M4-M5 SSI-7485-Mod-2 ROZELLE INTERCHANGE COMMUNITY COMMENT

We would like to see better urban outcomes for its 100 year lifespan

City West link perspective MOD 2 August 2019

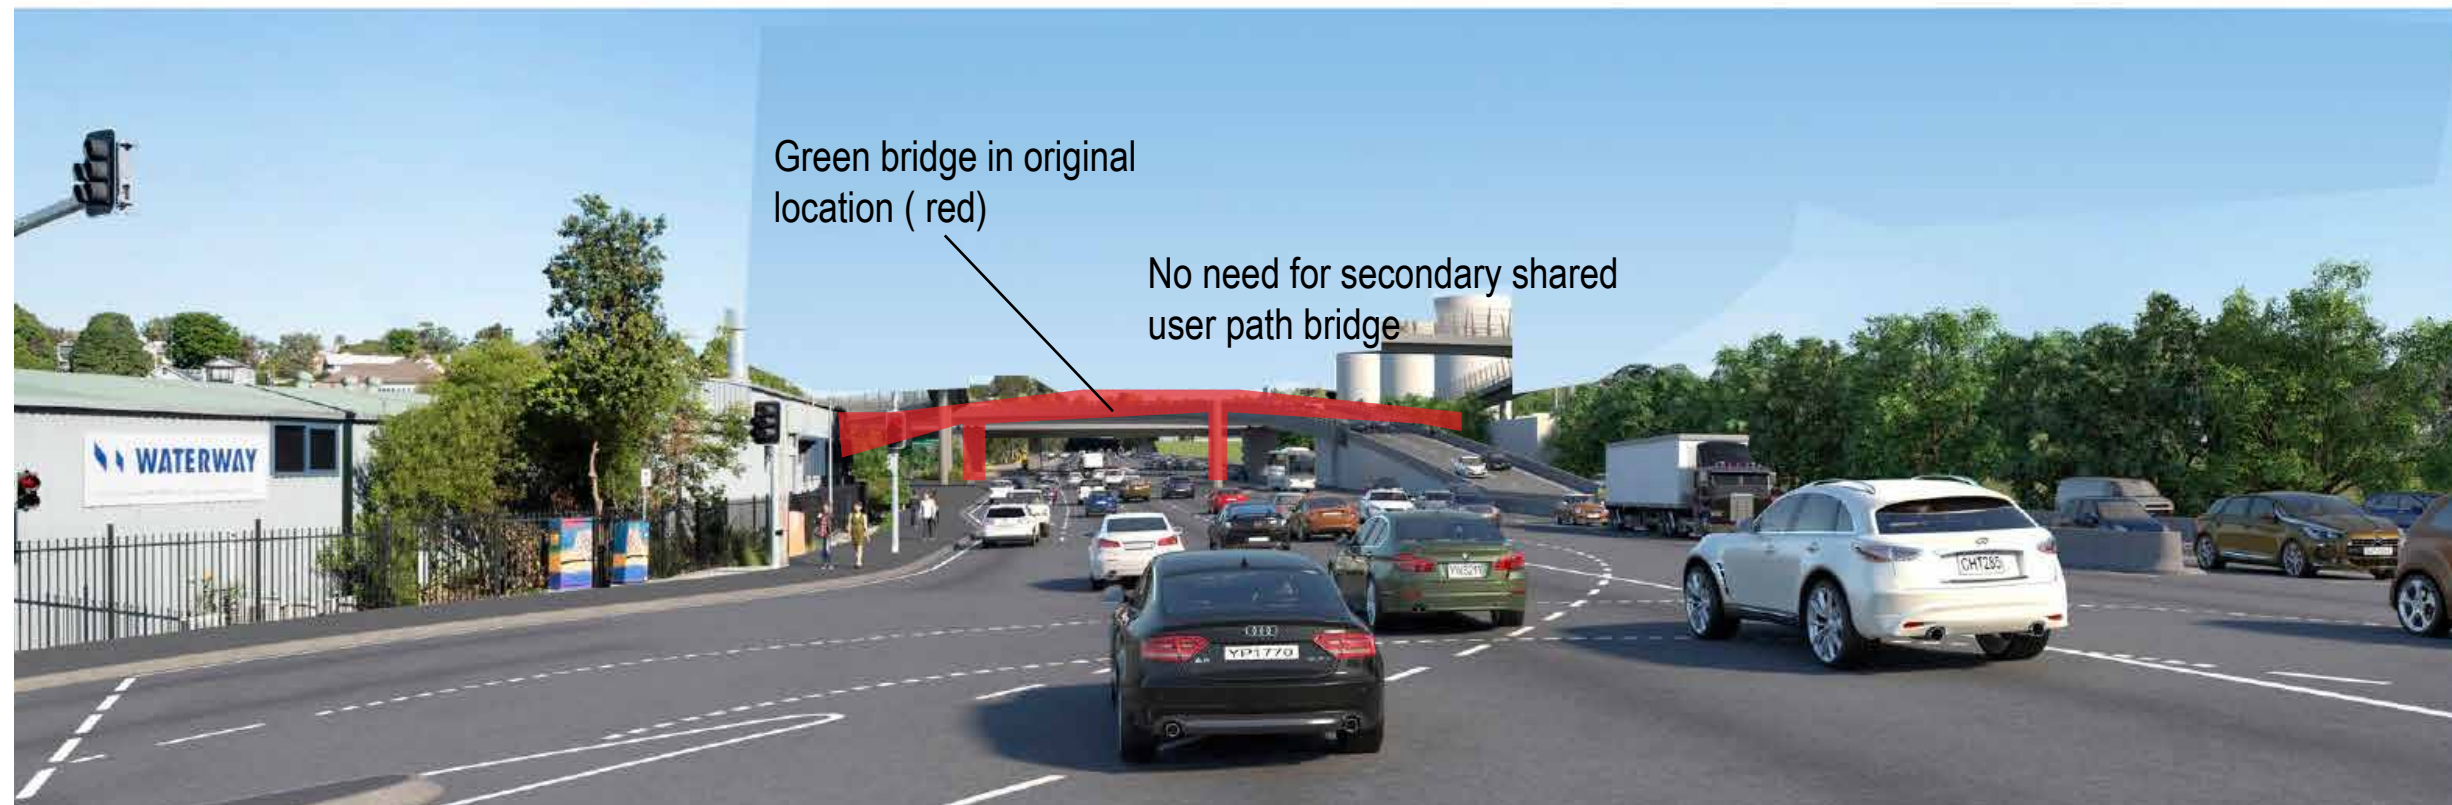
To provide the necessary clearance over the overpass, the additional cycle / pedestrian bridge is elevated an additional say 3.0m. At 1:21 to include landings that is adding approx 126m length to the overpass. [2x 63m]

Support beam is likely to look thicker than illustration given existing Beatrice Brush Bridge and similar recent bridges on Warringah Road

APPROVED EIS - SINGLE TRAFFIC LIGHT

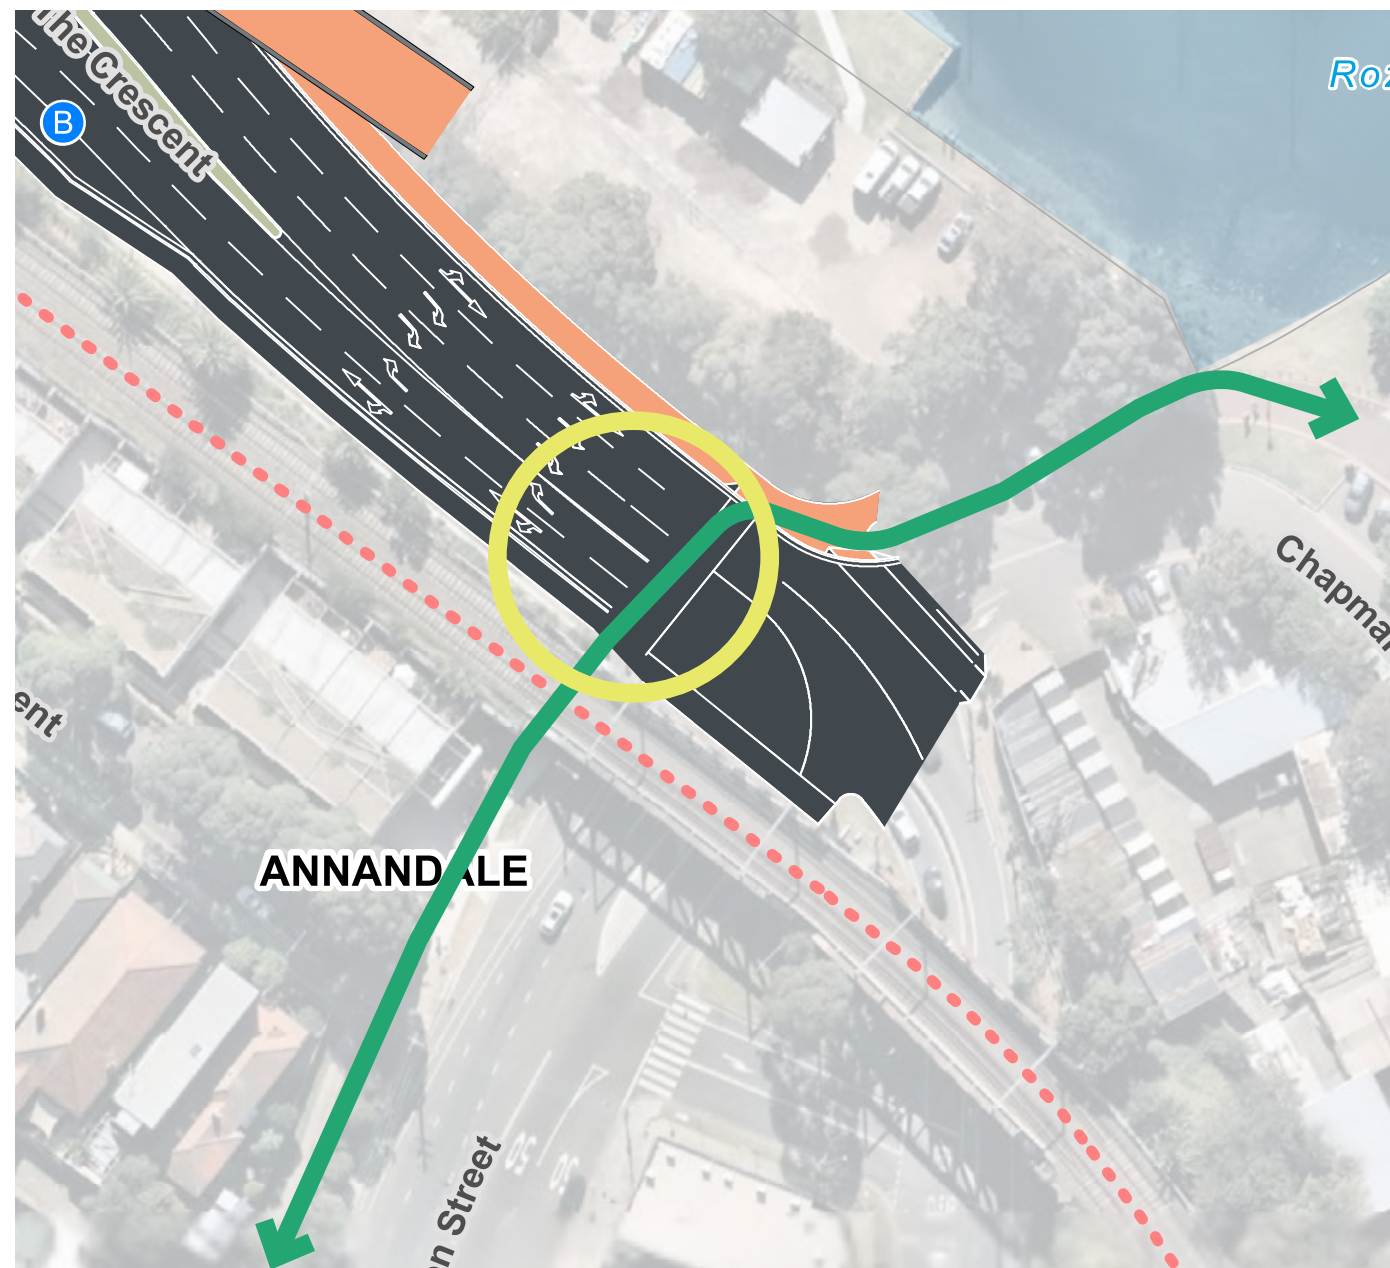
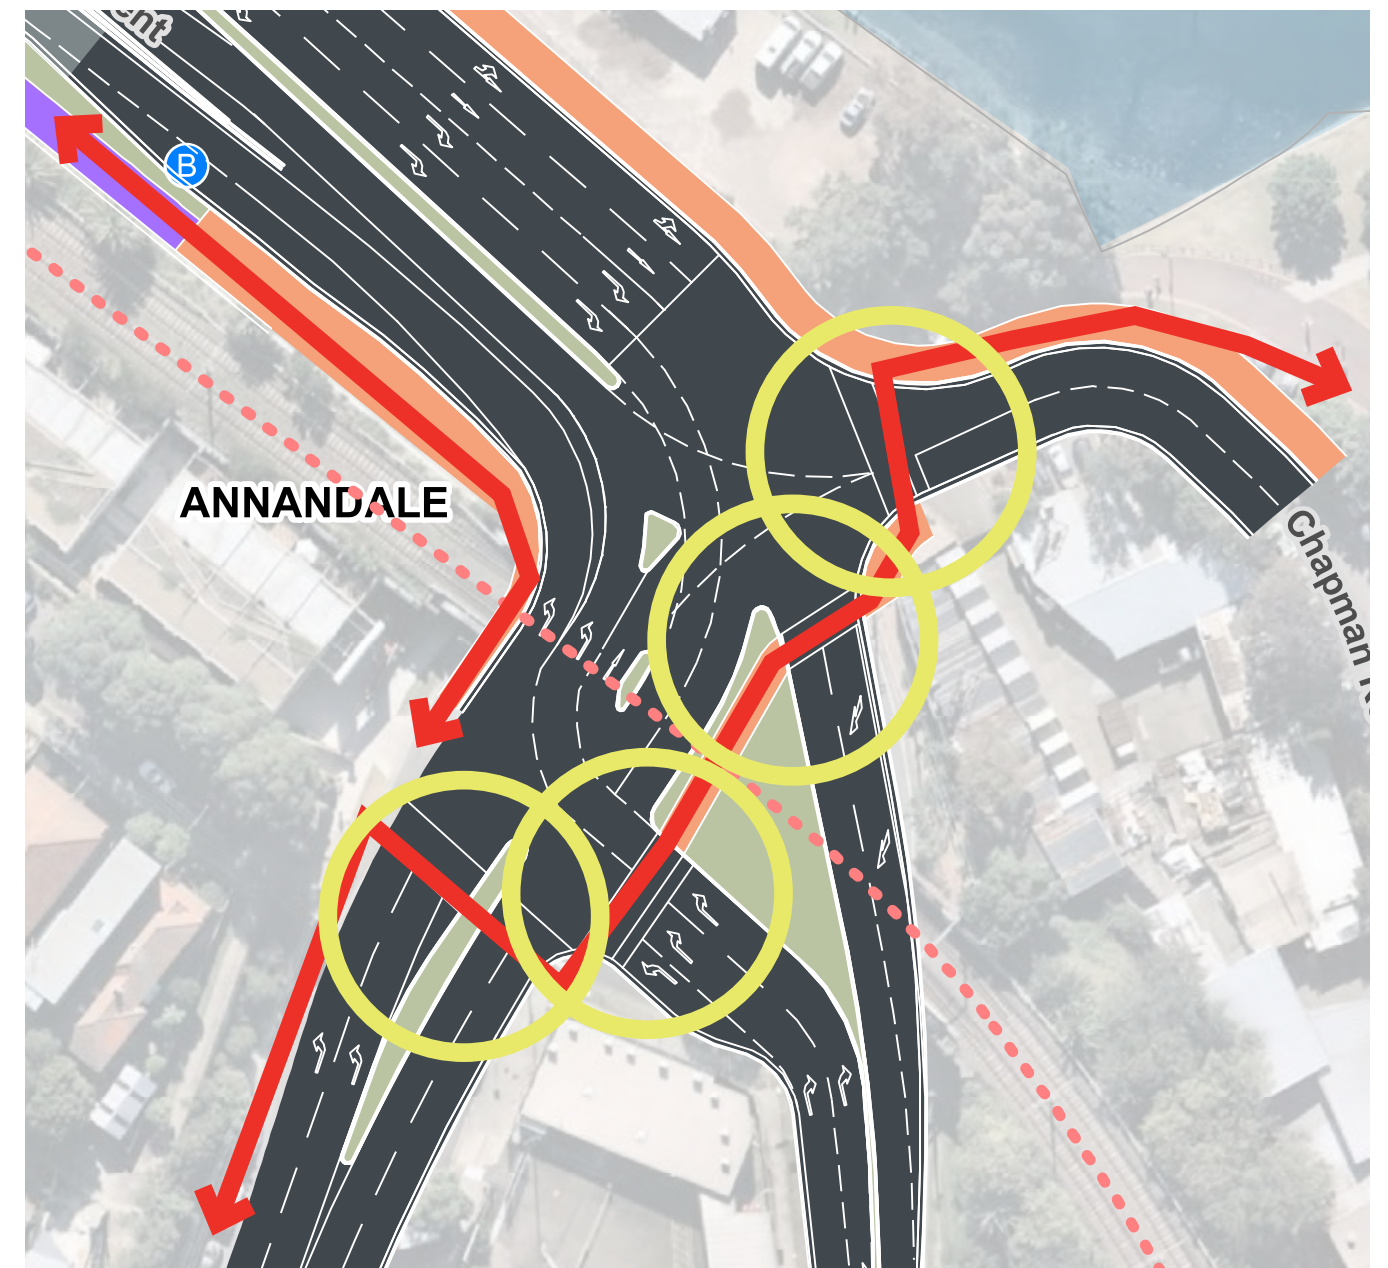
- PROPOSED SCHEME
- FOUR TRAFFIC LIGHTS
 - 5M CLIMB
 - POTENTIAL SIX MINUTES TO CROSS (90 seconds x 4)

6-5 Photomontage 2: Indicative view east from Rozelle Bay light rail stop (without project)

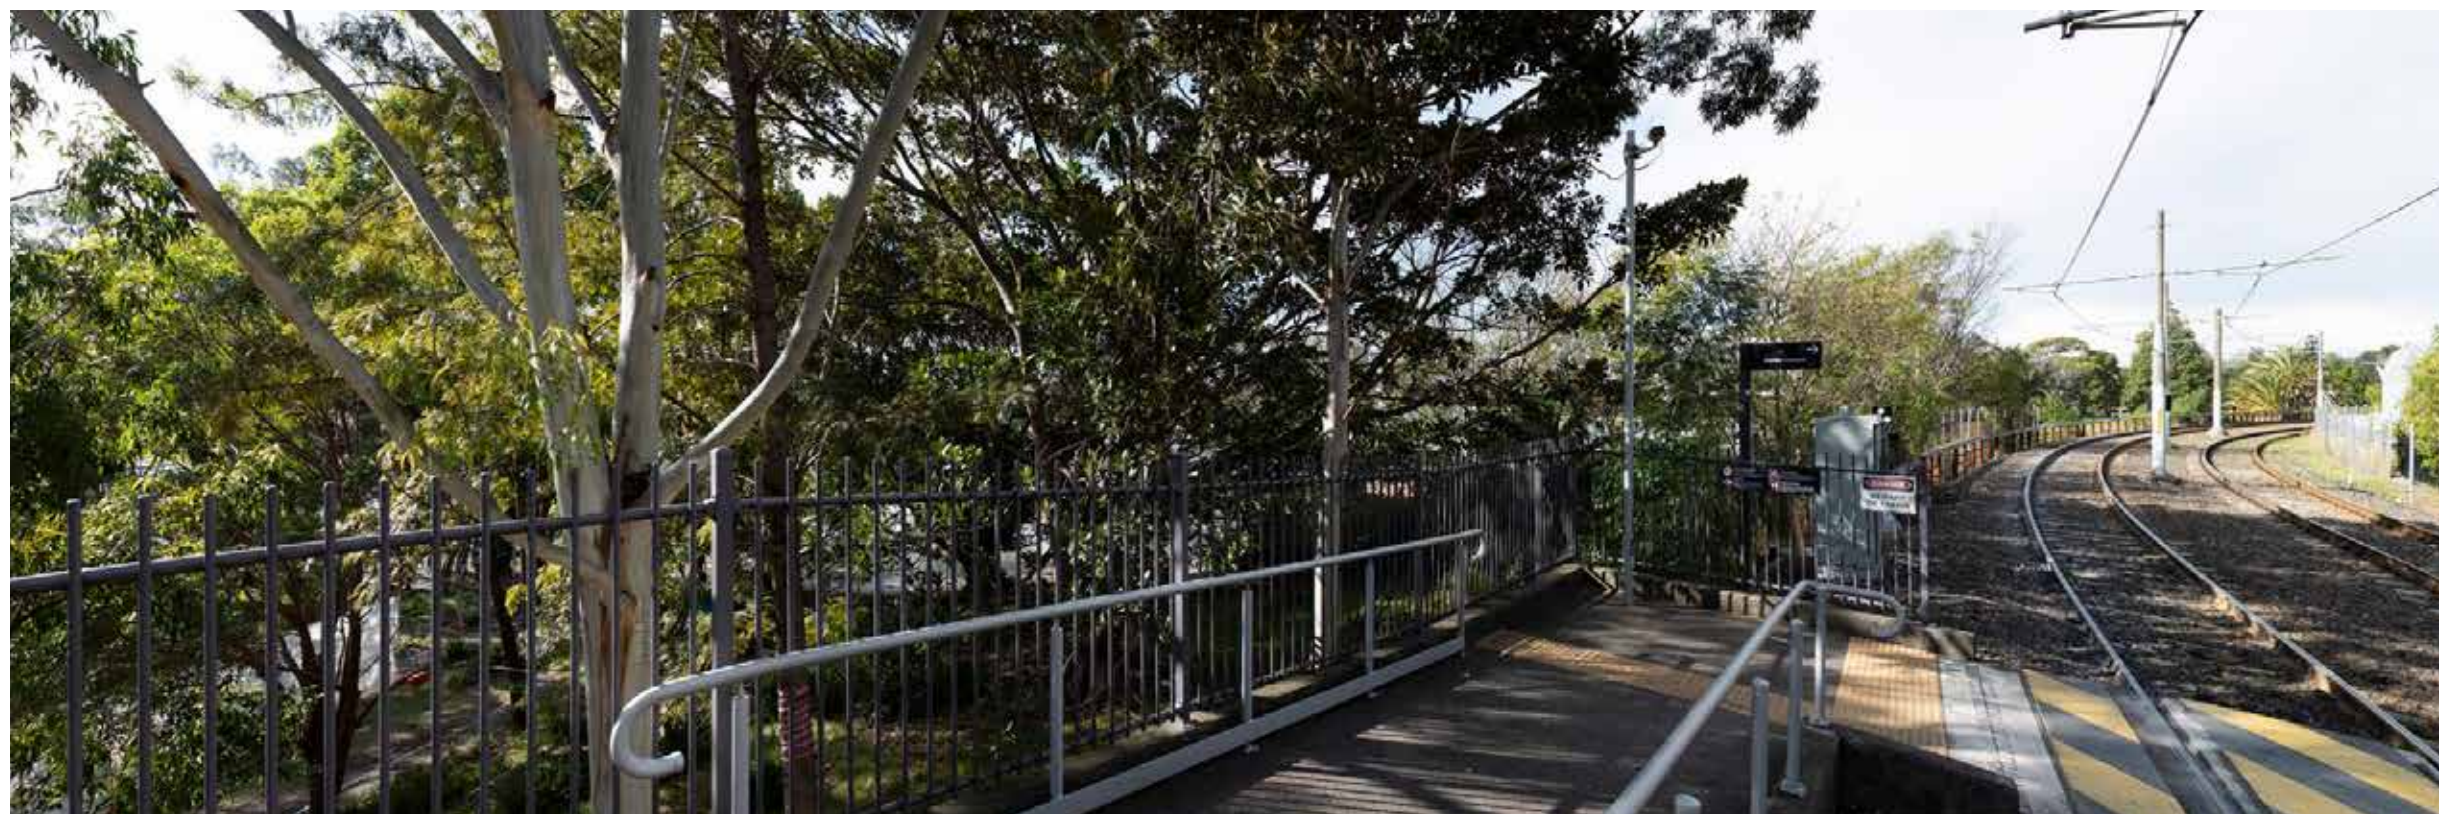
The overpass has been driven by level of service issues. However it is only improving it from F to C, and is likely to degrade further over time. Both option 1 and 2 were better urban outcomes.

It has forced the relocation of the green bridge impacting all the related connectivity issues outlined in the previous section. It has also forced the introduction of a second bridge that is very long and high to get over the down ramp.

It has significant visual impact issues itself. Its design speed is making it higher than the Green bridge. It blocks views to the harbour from the relocated green bridge. Light poles will further add to its visual height. It also impacts the mural.

The 165m tunnel option 2 was discarded due to constructability and other concerns. Options to simplify it by limiting the tunnel to 120m should be addressed. The long length drives a requirement for mechanical ventilation, and therefore a deeper trench and a longer tunnel, all adding greatly to the cost. Option 2 needs to be revisited.

Overpass
blocks views
from Green
Bridge to water
